DELEGATED APPLICATION REPORT

App Ref: PL/26/0053 Listed building consent (Alt/Ext)

Address: 6 CHURCH STREET, CAVERSHAM, READING, RG4 8AT

Proposal: Part-retrospective application for the installation of new M&E services, installation of a new kitchen and bathroom, construction of sump and pump behind the front door to remove water after surface water flood events, installation of a raised floor structure over the historic brick sett snug floor and installation of new fixtures, fittings and finishes.

Existing and proposed floor plans

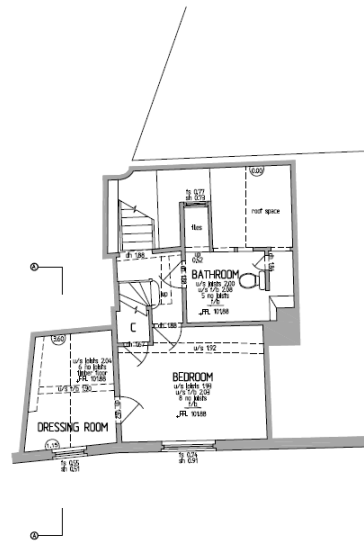
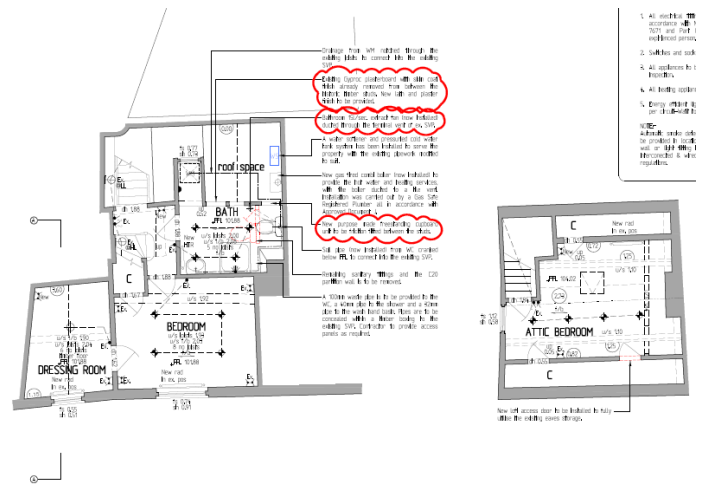
RBC Conservation Consultations – further details would be required. Summarised as follows:

Entrance Lobby:

- Subject to the details of the proposed sump pump, including the new drainage pipe
- Subject to the details of the new suspended floor (section drawing)
- Subject to details of the new timber studwork, including elements such as airbricks and material specifications for the front wall, is required (section drawing)

Sitting Room (comments above apply)

- Subject to details (section drawing) of the ceiling treatment in the sitting room are required – is this reversible, and how are the historic timbers proposed to not be harmed? The clarification is required on how the plasterboard will be fixed and what the visual impacts will be, whether a more breathable material could be considered instead of gypsum plaster

Snug (comments above apply)

- Subject to the details of the new timber floor to be put on the historic brick setts – a section drawing with material specs and transition between the two floor systems would be helpful. Please provide visual information/photographs of the original bricks so that they are recorded.
- For the ceiling, 'to improve the aesthetics' is not by itself a heritage justification. The Council looks for an introduction of less harmful fixings and a more compatible approach with the original structural elements.

Kitchen

- In addition to the details provided for the sump pump, details of the extractor and a section elevation for the new serving opening between the kitchen and sitting room are required

Dressing room

- Subject to the details of new oak floorboards, including how to be fixed over the existing floor joists, is required.

Bathroom

- Details of the removable shelving, tile vent/extractor system are required,

Attic

- Further information and clarification are required for the second paragraph about the works to the party wall that includes modern materials again.

Planning Officer note: Following the provision of further information received on 22/04/2026 (outlined in "Plans/Information considered" section above), the Conservation Officer confirmed that no further objection, subject to conditions.
